Application for Licence Amendment

Licence Number	L6168/1991/11
Licence Holder	BHP Iron Ore Pty Ltd
ACN	008 700 981
File Number	DER2013/001190-1
Premises	Yandi (Marillana Creek) Iron Ore Mine Mining Tenements M270SA, G47/12, G47/13, G47/14, G47/15, G47/16, G47/17, G47/18 and G47/19 NEWMAN WA 6753
Date of Report	23 October 2024 (FINAL)
Decision	Revised licence granted

Figure 3: Trial monitoring bore locations

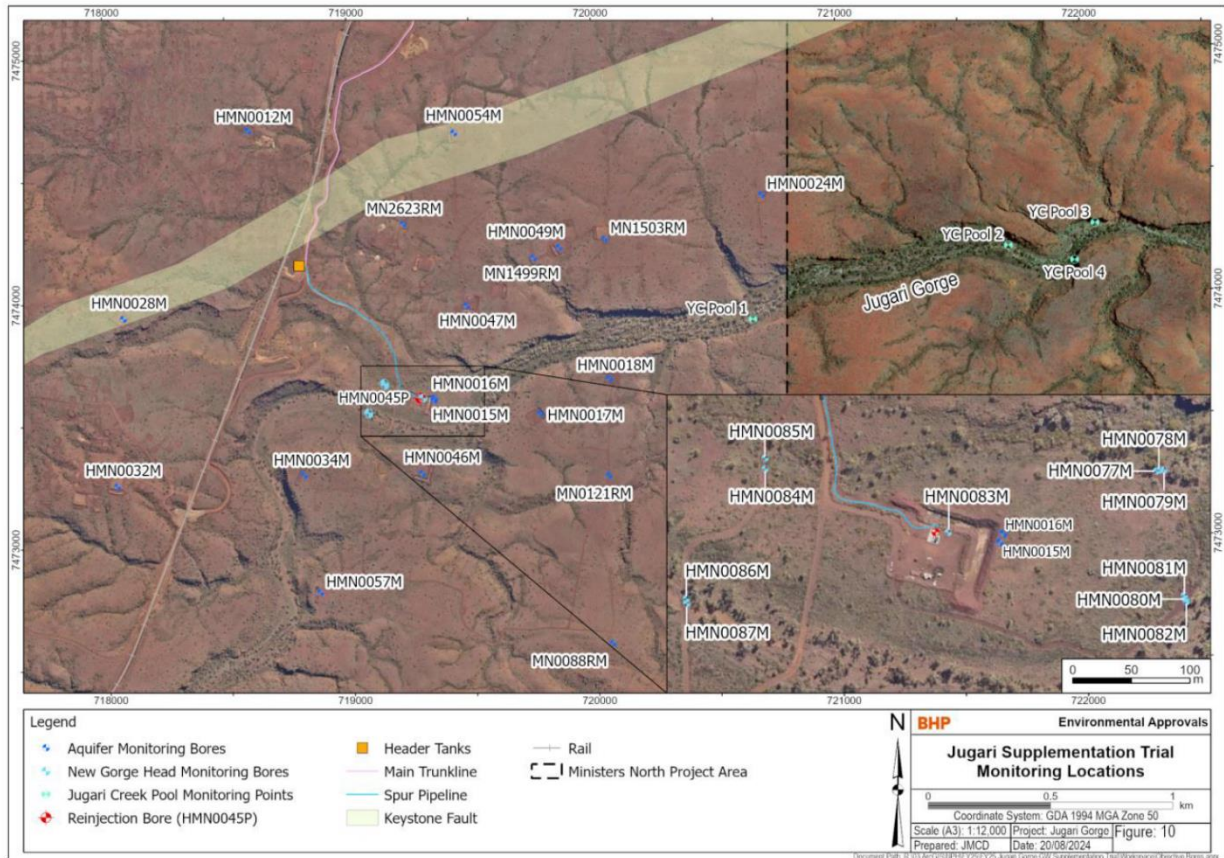
As outlined in the TARP, the applicant has proposed to undertake fortnightly groundwater quality monitoring for the two adjacent monitoring bores to the reinjection area (bores HMN0015M and HMN0016M) and the 18 monitoring bores within the Ministers North Aquifer. The applicant has not included monitoring of groundwater quality for the six bores located along the length of the gorge (bores HMN0077M to HMN0082).

- **Condition 26 (Table 15):** The Delegated Officer has included a new condition on the licence to undertake monitoring of point source emissions to groundwater and ambient groundwater quality for all trial monitoring bores including the bores located along the length of the gorge and the additional discharge point (Yandi Transfer Tanks to reinjection bore HMN0045P), to obtain a quantitative assessment of local groundwater quality and for any groundwater chemistry changes during the trial.
